Interactive comment on “Full field assessment of wind turbine near wake deviation in relation to yaw misalignment” by Juan-José Trujillo et al.

Juan-José Trujillo et al.

Received and published: 28 February 2016

Fig. 1. Approximated theoretical expectation of the effect of wind turbine misalignment on wake skewness with respect to induction (a) or thrust coefficient (C_t)

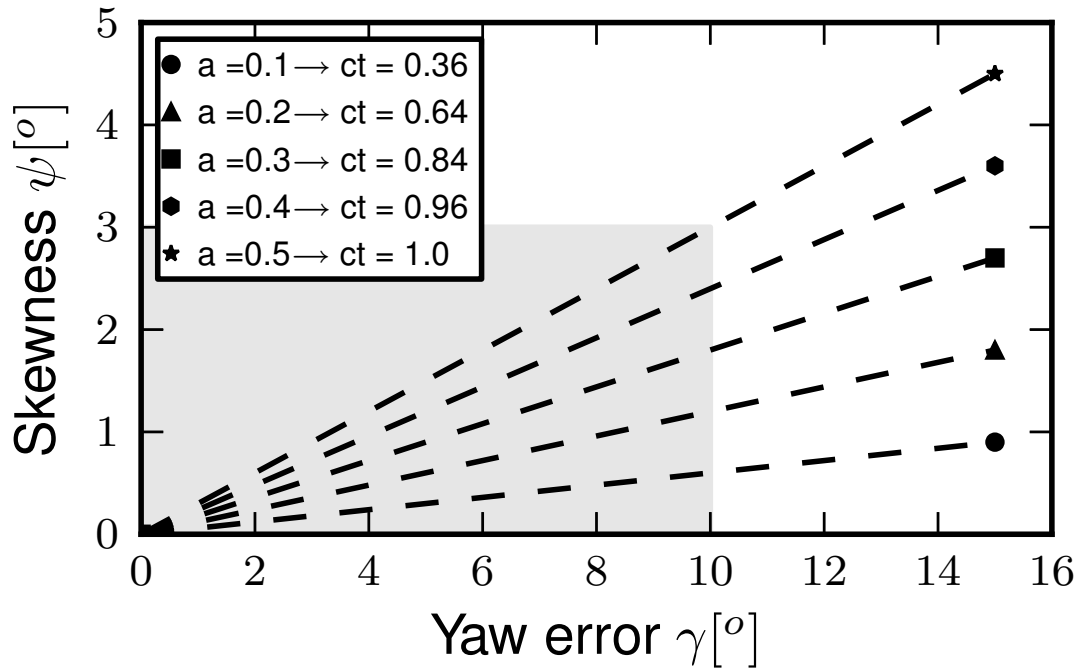
\$4.1. Knowing the thrust coefficient, it is possible to assess the expected velocity deficit and so, the expected axial induction factor. One can then compare this velocity deficit with the one obtained in the present data base. One can also assess the expected

skew angle of the wake, which depends on the axial induction factor and the yaw angle. According to a rapid calculation, the skew angle of the wake should be 1.16 times higher than the yaw angle. However, this skew angle is not taken into account in the present study: why?

You are right that there is an expectation of a skew angle. As we mention in the discussion it is not possible to resolve the very small skew angles which are in consideration with the measurement setup in this research. As you point out we do not explain in detail the background of this to be concise in the paper. A solution could be to add an explanation into a short annex to the paper.

From theoretical considerations the wake deviation (χ_o) can be approximated as $\chi_o \simeq (0.6a + 1) \cdot \gamma$ (see vortex model in Burton et al. 2011) what derives into a skewness equal to $\psi \simeq 0.6a\gamma$. This behaviour is depicted in Fig. 1, where an approximate value of thrust coefficient C_T is given for the case of no misalignment. This is done taking into account that based on the vortex model the thrust coefficient is rather unaffected by yaw errors in the order of magnitude shown in Fig. 1.

The shaded area depicts approximately the yaw misalignment values which are covered during this experiment. As a consequence the highest values of skewness that could be expected are below $\psi \simeq 3^\circ$. However, this value lies already in the order of the typical uncertainty assumed for nacelle wind vanes. Therefore we conclude that the wake skewness can not be resolved from pure yaw misalignment measurement by the standard wind vane at the nacelle in this experiment.
